Access Compliance Report Public Rights-of-Way (Curb Ramps)

Main Street: KENSINGTON_RD Cross Street: TUCKER_LN Location: NE

ADA ID: RPRK211220134817 Ramp Type: Type 1 - Perpendicular Diagonal Initial Pass/Fail: Pass Overall Compliance: No Severity Score: 12

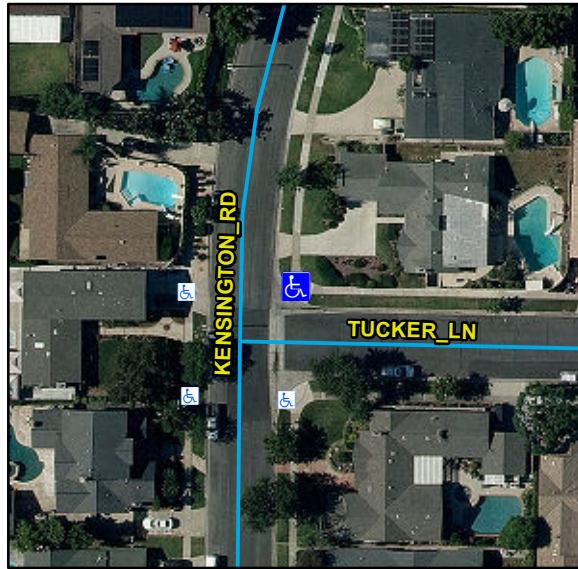
Compliance	Description	Data	Compliance	Description	Data
N/A	Ramp Length (in)	81	N/A	Flare Type LT	
Yes	Ramp Width (in)	48			Sloped
Yes	Ramp Run Slope (%)	8.1	N/A	Flare Slope LT (%)	5.8
Yes	Ramp Cross Slope (%)	0.3	N/A	Flare Traversable LT	No
N/A	Landing Present	Yes	N/A	Flare Type RT	
N/A	Landing Length (in)	49			Sloped
Yes	Landing Width (in)	48	N/A	Flare Slope RT (%)	3.4
Yes	Landing Run Slope (%)	1.6	N/A	Flare Traversable RT	No
Yes	Landing Cross Slope (%)	1.3	No	DWS Provided	No
N/A	Landing Movement Obstructed?	No	N/A	DWS Contrast	N/A
	Landing Movement Type	N/A	N/A	DWS Length (in)	N/A
N/A	Landing Shared	No	N/A	DWS Full Width	N/A
N/A	Clear Space	Yes	N/A	DWS Offset Left (in)	N/A
N/A	Clear Space To Crosswalk (in)	48	N/A	DWS Offset Right (in)	N/A
N/A	Marked Crosswalk 1	No	N/A	Marked Crosswalk 2	No
	Crossing 1 Direction	W		Crossing 2 Direction	S
	Marked Crosswalk 1 Width (in)	N/A		Marked Crosswalk 2 Width (in)	N/A

N/A	Ramp Inside Crosswalk 1	N/A	Yes	Ramp Inside Crosswalk 2	N/A
	Crossing 1 Slope (%)	3.9		Crossing 2 Slope (%)	5.8
	Crossing 1 Cross Slope (%)	0.2		Crossing 2 Cross Slope (%)	0.5
Yes	Gutter Ponding	No	Yes	Curb Slope	2
Yes	Gutter Lip Height (in)	0		Road Run Slope (%)	0.1
Yes	Gutter Run Slope (%)	0.6		Road Cross Slope (%)	0.9
Yes	Gutter Cross Slope (%)	0.5			
Yes	Overall Surface Condition: Acceptable		No	Perp Joint Present	No
	Cross Gutter Present?	Yes		Spandrel Present?	Yes
	Replace Cross Gutter?	No		Replace Spandrel?	No

Remove & Replace Curb Ramp With Two New Directional Ramps or Equivalent.
